| PROJECT | PROPOSED DISTRICT PLAN: REZONING SUBMISSIONS: MALVERN PACKET |
| SUBJECT | PEER REVIEW OF REBUTTAL EVIDENCE |

This technical note provides my review of rebuttal evidence for DPR-0416, DPR-0449, and DPR-0476.

Figure 1: DPR-0416 subject sites

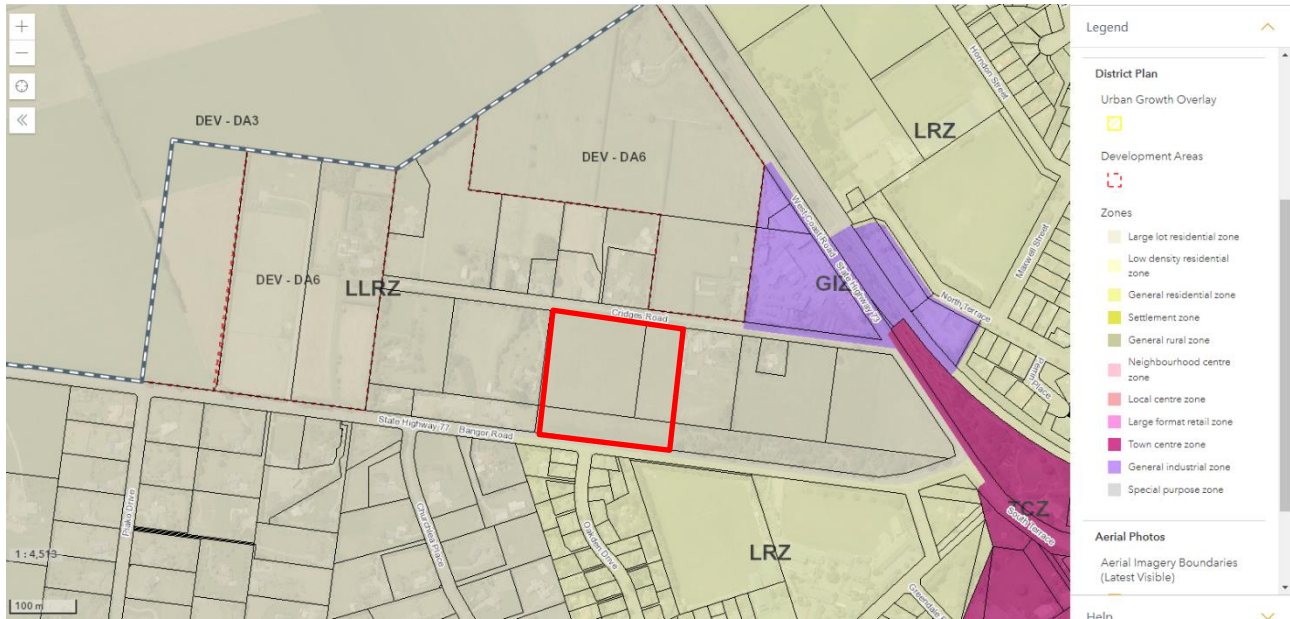
- ◆ Amend zoning from Large Lot Residential Zone (LLRZ) to Low Density Residential Zone (LRZ) for the submitters land, being legally described as Section 4 Darfield VILL SETT, Section 6 Darfield VILL SETT and RS 39127
- ◆ The sites are near Development Area DA6, as shown in Figure 1 and Figure 2.

- ◆ Bangor Road is a State Highway (SH77), meaning Waka Kotahi are the Road Controlling Authority
- ◆ The sites also have frontage to Cridges Road. Cridges Road is not identified in Appendix 2 – Rooding Hierarchy of the Proposed District Plan, and therefore is considered to be a Local Road

- ◆ The Submitters experts estimate that rezoning the sites from LLRZ to LRZ is expected to increase the potential yield from around 6 residential lots to 39 residential lots

- ◆ This is estimated to result in around 39 peak hour vehicle trips
- ◆ The site is within reasonable walking distance (approximately 1km) of the Darfield Town Centre, and there is an existing footpath on south side of Bangor Road between the sites and the town centre, however a safe pedestrian crossing facility would be required in order for access to be provided

- ◆ The sites are adjacent to parts of DEV-DA6, which provides an opportunity to create more cohesive development of the sites, particularly a roading connection between Bangor Road and Cridges Road to improve permeability of the transport network

- ◆ While I consider that direct vehicle access onto Bangor Road would likely be unfavourable, I consider that TRAN-R4 and TRAN-REQ4 allow for this to be assessed during future resource consent applications

- ◆ I consider that it is preferable that development within the sites is accessed from a new vested road, connecting between Bangor Road and Cridges Road. The location and design of this road, and any new intersections onto Bangor Road and Cridges Road, can be managed via SUB-R13 through the future subdivision application

- ◆ Mr Carr notes that the existing 4.5m wide carriageway on Cridges Road may not be sufficient to serve the sites, however he notes that there are no obvious impediments to widening the carriageway. I agree with Mr Carr. My preference is to show a requirement for carriageway widening on DEV-DA6, however I acknowledge that this might be outside of the scope of the submission

- ◆ In general, I consider that the transport effects of the proposed rezoning can be adequately managed through the future resource consent process.
- ◆ However, to ensure integrated land use and transport outcomes, I recommend that the sites be incorporated within DEV-DA6 (as shown in Figure 2), along with the following amendments

- DEV-DA6 plan includes an indicative road between Bangor Road and Cridges Road
- DEV-DA6 “Access and Transport” section includes the following additions

A primary connection shall run from State Highway 73 and connect to the development area to the northwest. A Two secondary connections shall run through the area to Cridges Road and Bangor Road. A safe pedestrian crossing facility shall be provided on Bangor Road, near Oaken Drive. Cridges Road shall be upgraded to comply with Council’s Engineering Code of Practice.

Roading is to integrate with the ODP, or any approved subdivision plan, for the adjoining development area.

Figure 3: Approved subdivision plan for Ascot Park

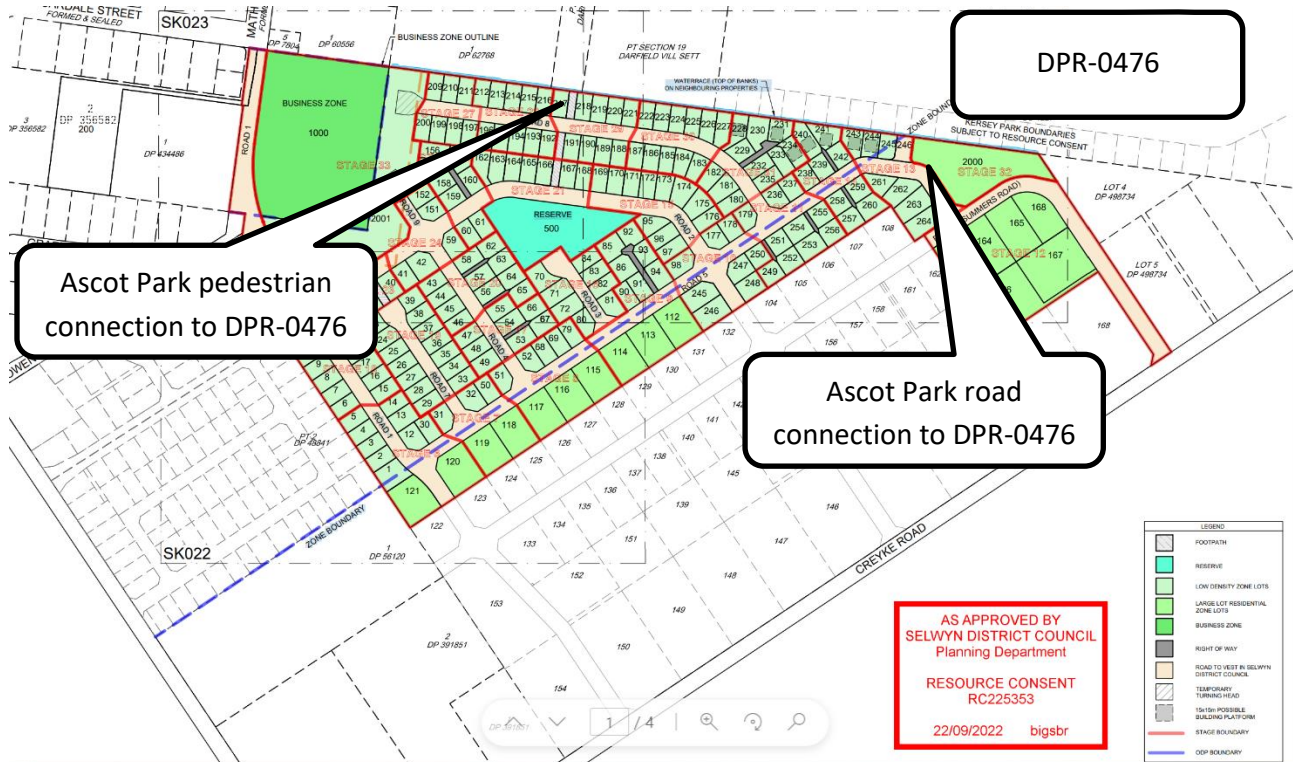
If there is scope to do so, I recommend that transport connectivity is provided between DPR-0476 and the adjacent Ascot Park residential subdivision (Proposed Darfield 1 Development Area). I understand that Ascot Park has an approved subdivision consent (RC225353, dated 22/09/22), which includes a road and a pedestrian connection to the boundary of DPR-0476 as shown below in Figure 3. I recommend that there is a requirement placed on submitter DPR-0476 to extend these connections into the DPR-0476 site.
